Service Bulletin

SEB93-15

ELECTRICAL PUSH-PULL SWITCH REPLACEMENT

TITLE PUSH-PULL SWITCH REPLACEMENT - T41A

Figure 1. Push-Pull Switch Replacement (Sheet 2)

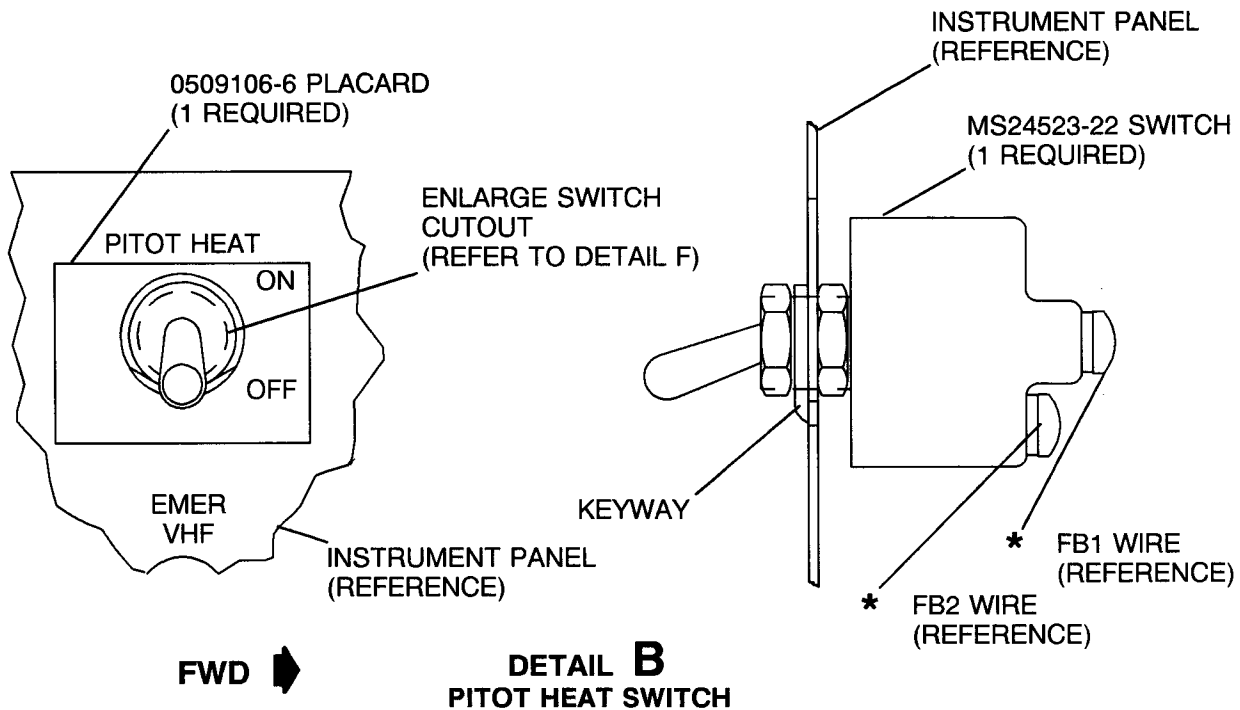
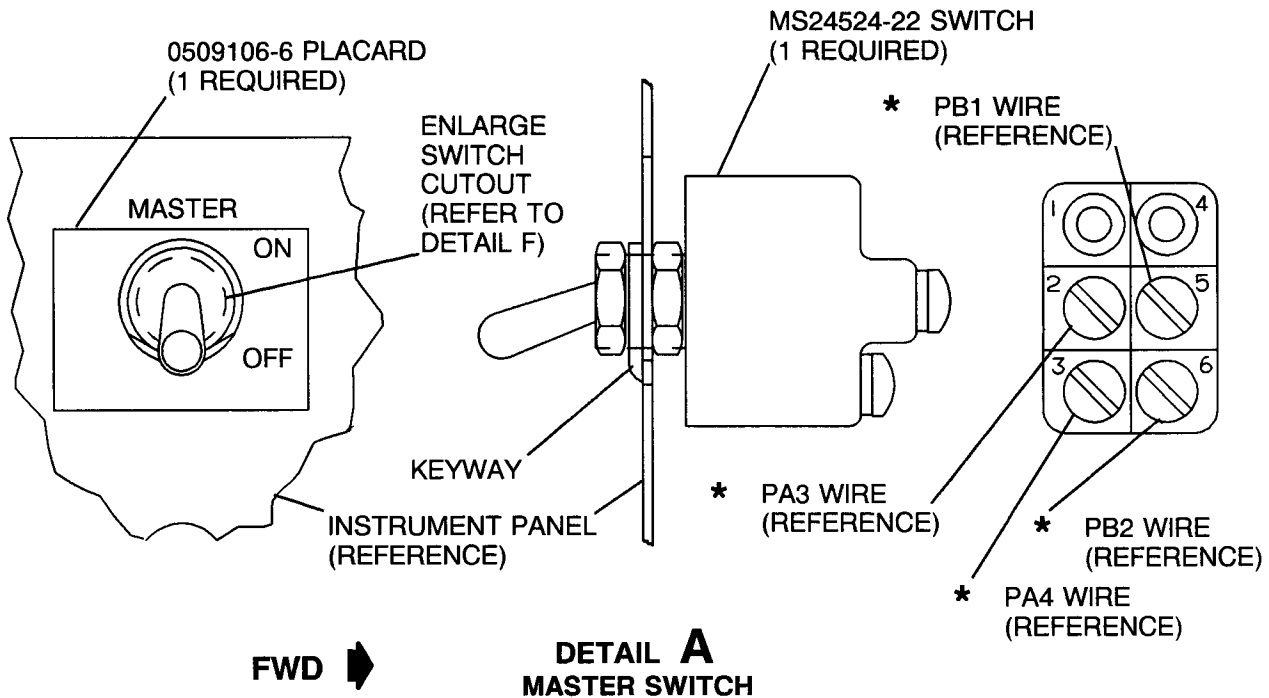
- B. (Refer to Figure 1, Detail A, Sheet 2) Gain access and remove existing master switch from instrument panel. Disconnect wiring and remove and discard switch.

- E. (Refer to Figure 1, Detail A, Sheet 2) Install 0509106-6 placard on instrument panel as shown.
 - F. Connect the wires to the switch terminals as shown on the illustration.

- B. (Refer to Figure 1, Detail B, Sheet 2) Gain access and remove existing pitot heat switch, if required, from instrument panel. Disconnect wiring and remove and discard switch.

Figure 1. Push-Pull Switch Replacement (Sheet 3)

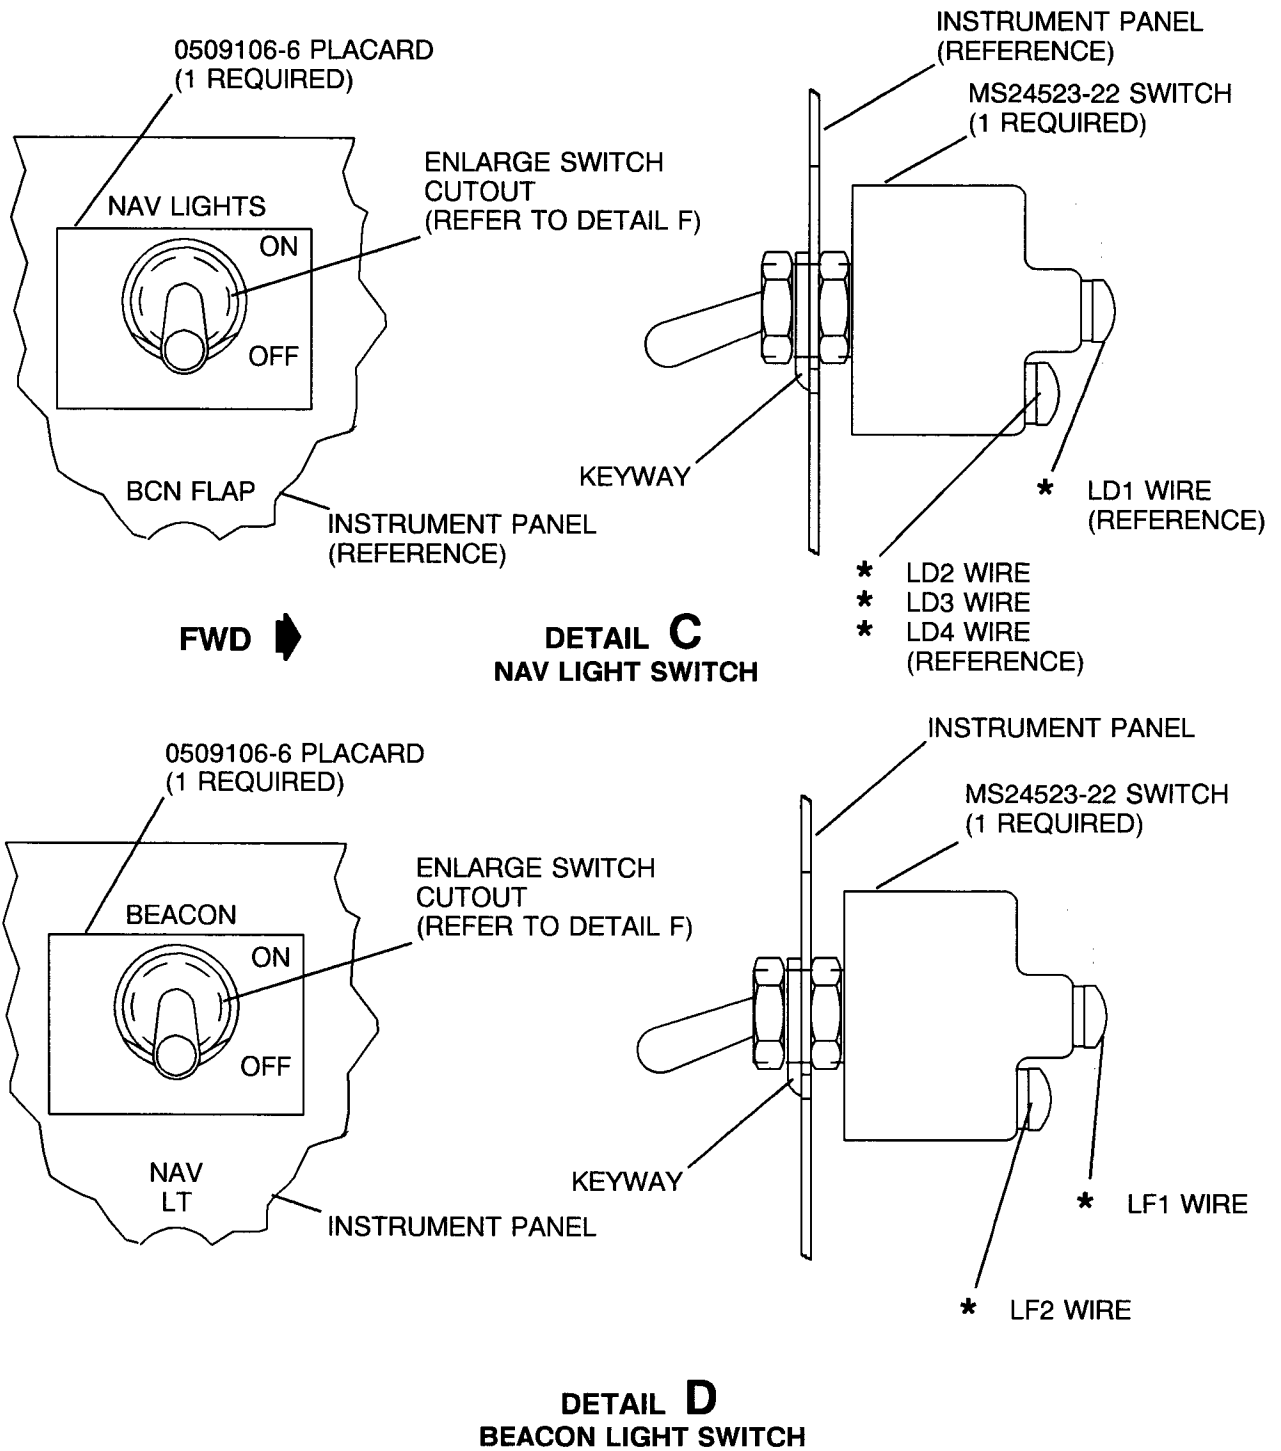
- C. (Refer to Figure 1, Detail D, Sheet 3)..Gain access and remove existing beacon light switch, if required, from instrument panel. Disconnect wiring and remove and discard switch.

- B. (Refer to Figure 1, Detail C, Sheet 3) Gain access and remove existing nav light switch from instrument panel. Disconnect wiring and remove and discard switch.

- E. (Refer to Figure 1, Detail C, Sheet 3) Install 0509106-6 placard on instrument panel as shown.
 - F. Connect the wires to the switch terminals as shown on the illustration.

DETAIL E
LANDING LIGHT SWITCH

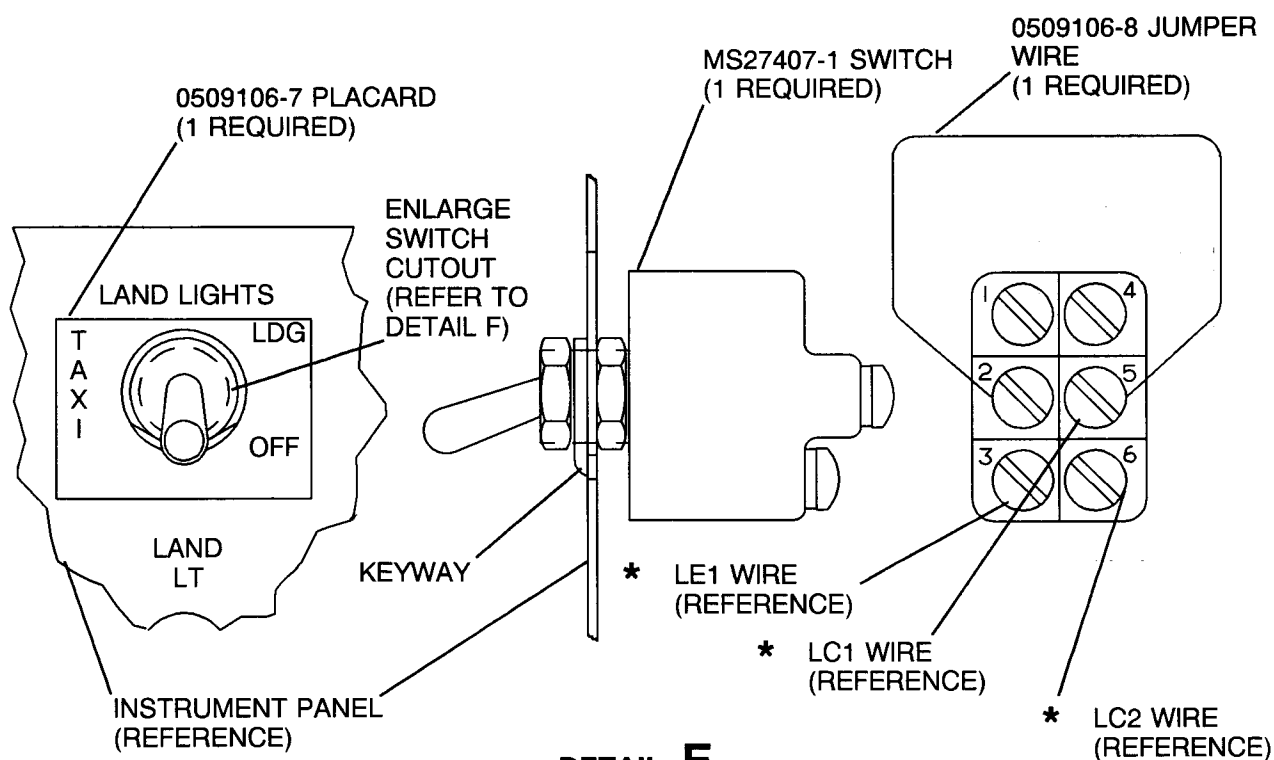
- B. (Refer to Figure 1, Detail E, Sheet 4) Gain access and remove existing landing light switch from instrument panel. Disconnect wiring and remove and discard switch.

- E. Refer to Figure 1, Detail E, Sheet 4) Install 0509106-7 placard on instrument panel as shown.
 - F. Connect the wires to the switch terminals and install 0509106-8 jumper wire on switch terminals as shown on the illustration.

DETAIL F
ENLARGED SWITCH CUTOUT IN INSTRUMENT PANEL

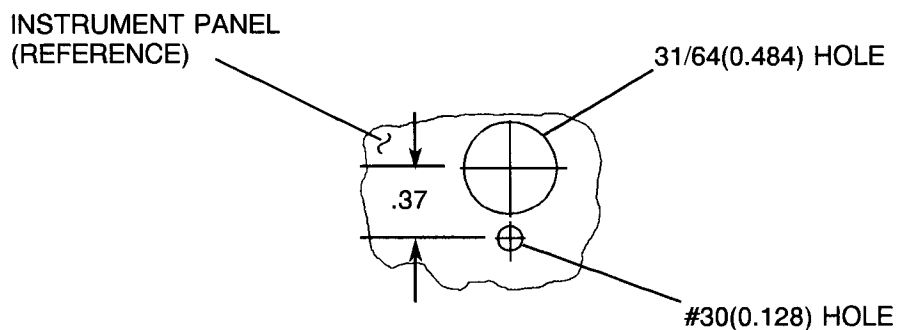
- C. Remove existing S1367-1-8 terminals from the affected wires as shown. Install the new S1367-1-6 terminals on the affected wires.
 - D. (Refer to Figure 1, Detail F, Sheet 4) Enlarge existing cutout in the instrument panel where the old switch was removed per the dimensions shown. Deburr and clean hole as required.

- D. Remove existing S1367-1-8 terminals from the affected wires as shown. Install the new S1367-1-6 terminals on the wires.
 - E. (Refer to Figure 1, Detail F, Sheet 4) Enlarge existing cutout in the instrument panel where the old switch was removed per the dimensions shown. Deburr and clean hole as required.

- C. Remove existing S1367-1-8 terminals from the affected wires as shown. Install the new S1367-1-6 terminals on the affected wires.
 - D. (Refer to Figure 1, Detail F, Sheet 4) Enlarge existing cutout in the instrument panel where the old switch was removed per the dimensions shown. Deburr and clean hole as required.

- C. Remove existing S1367-1-8 terminals from the affected wires as shown. Install the new S1367-1-6 terminals on the affected wires as shown.
 - D. (Refer to Figure 1, Detail F, Sheet 4) Enlarge existing cutout in the instrument panel where the old switch was removed per the dimensions shown. Deburr and clean hole as required.

Figure 1. Push-Pull Switch Replacement (Sheet 2)

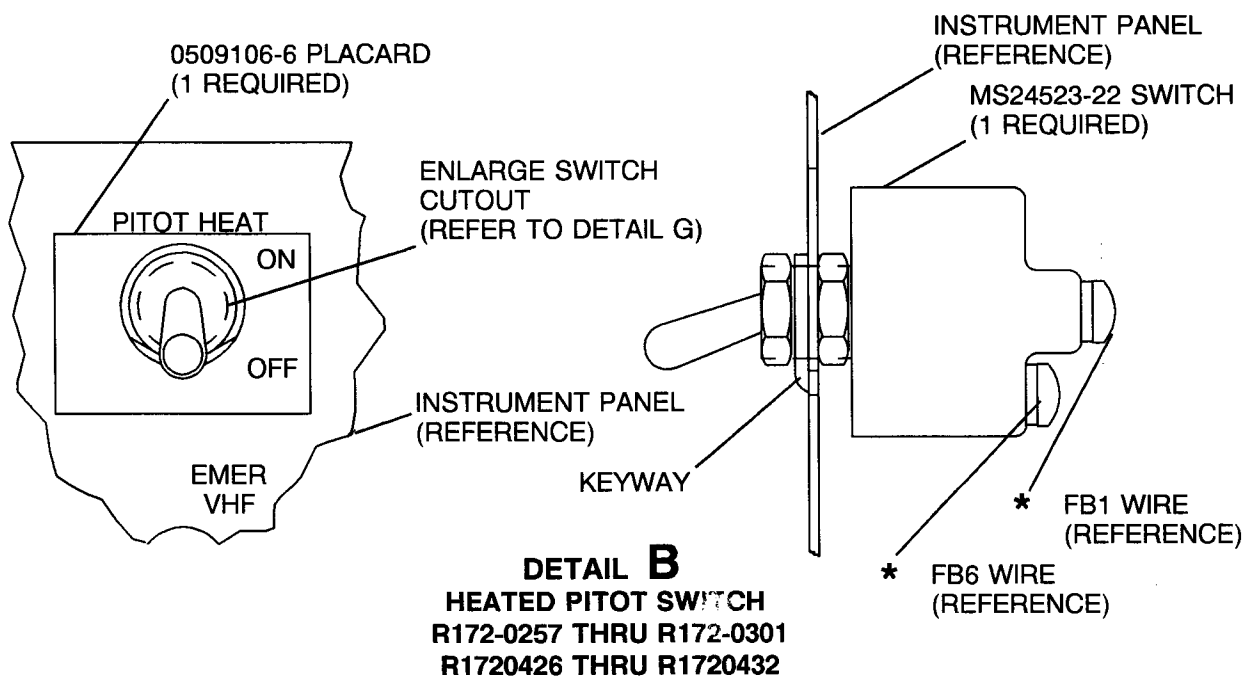
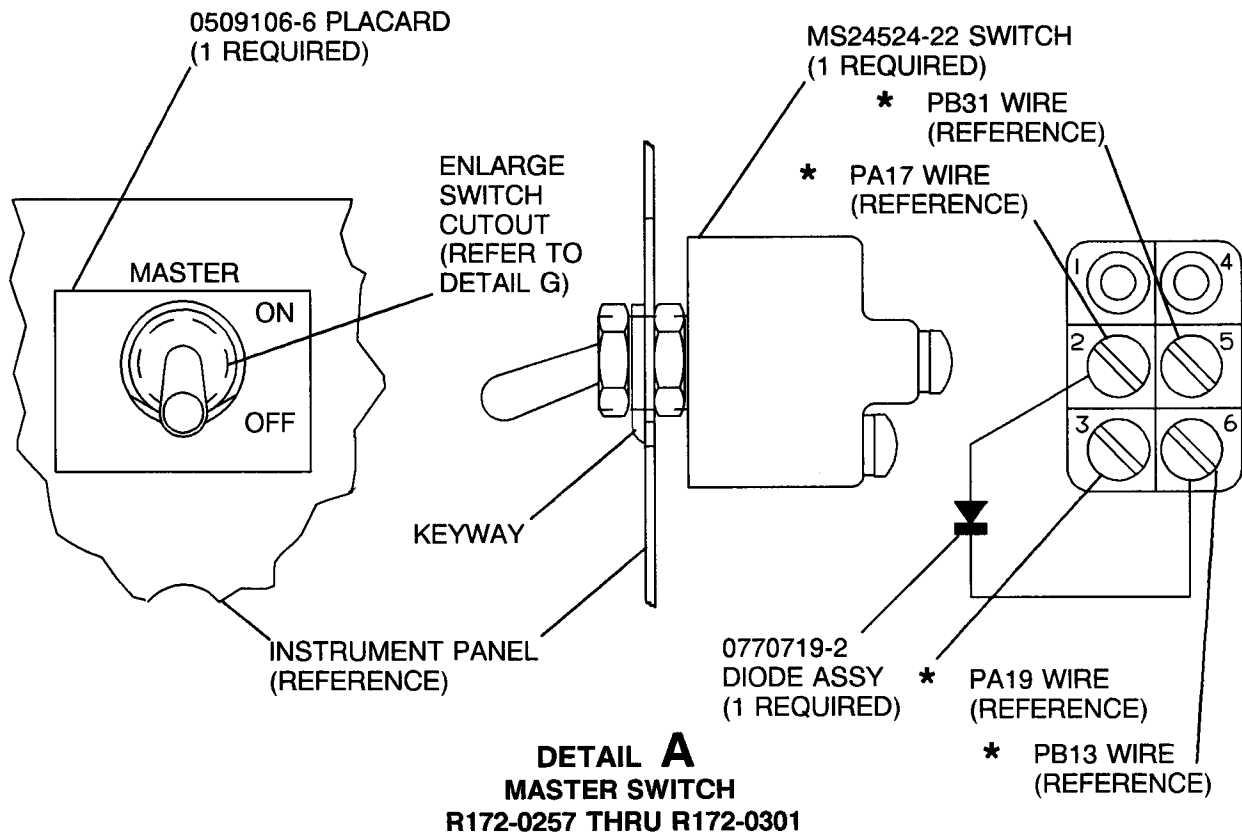
- B. (Refer to Figure 1, Detail A, Sheet 2) Gain access and remove existing master switch from instrument panel. Disconnect wiring and remove and discard switch.

- E. (Refer to Figure 1, Detail A, Sheet 2) Install 0509106-6 placard on instrument panel as shown.
 - F. Connect the wires to the switch terminals as shown on the illustration.

- B. (Refer to Figure 1, Detail B, Sheet 2) Gain access and remove existing pitot heat switch, if required, from instrument panel. Disconnect wiring and remove and discard switch.

Figure 1. Push-Pull Switch Replacement (Sheet 3)

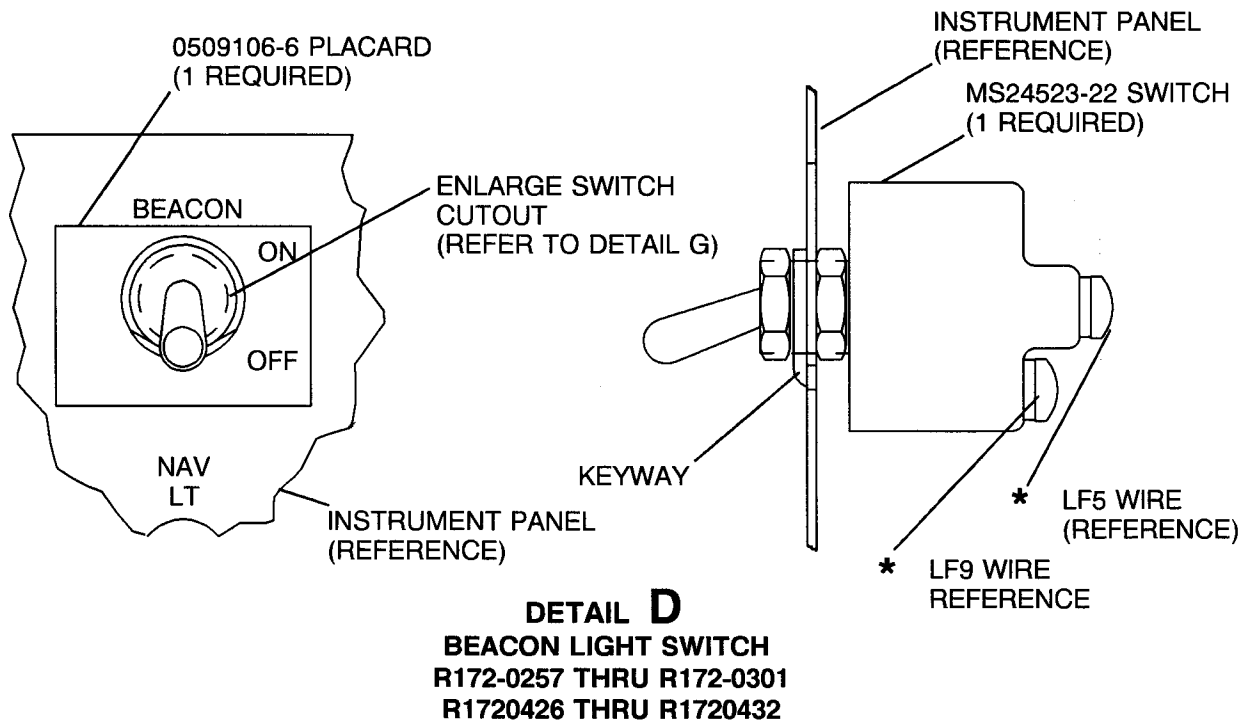
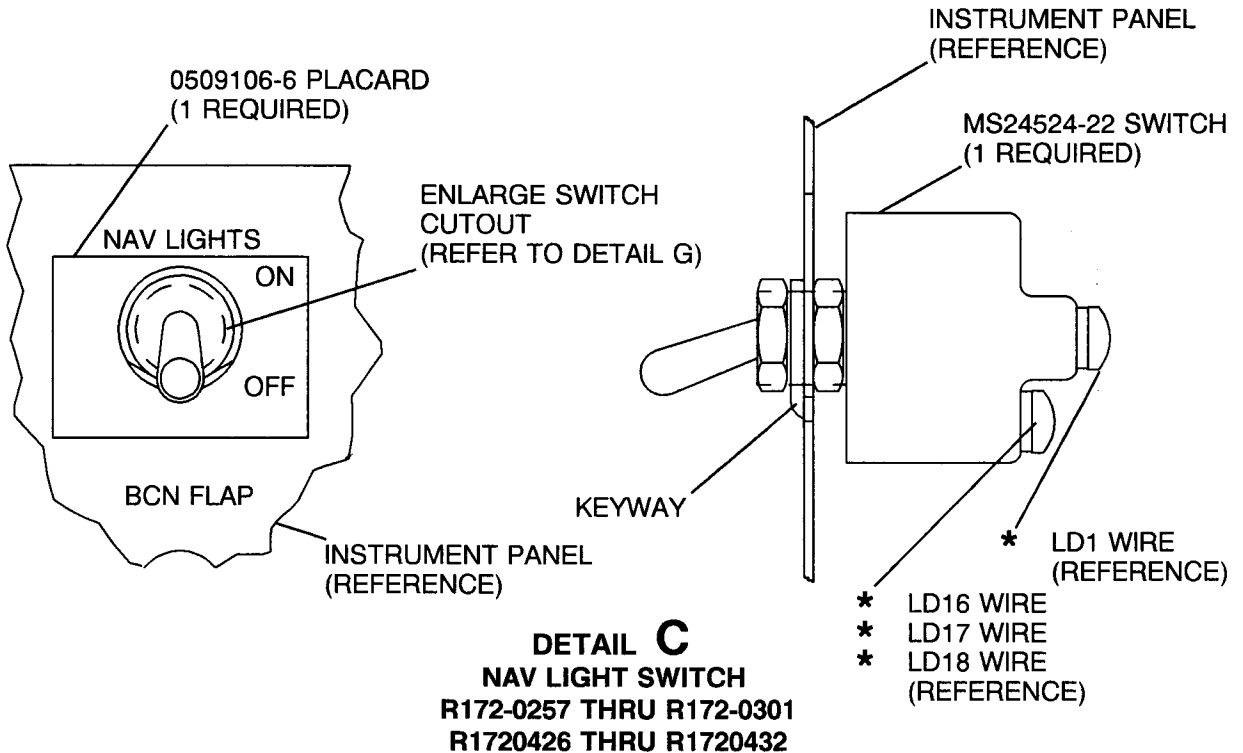
- C. (Refer to Figure 1, Detail D, Sheet 3) Gain access and remove existing beacon light switch, if required, from instrument panel. Disconnect wiring and remove switch.

- B. (Refer to Figure 1, Detail C, Sheet 3) Gain access and remove existing nav light switch from instrument panel. Disconnect wiring and remove and discard switch.

- E. (Refer to Figure 1, Detail C, Sheet 3) Install 0509106-6 placard on instrument panel as shown.
 - F. Connect the wires to the switch terminals as shown on the illustration.
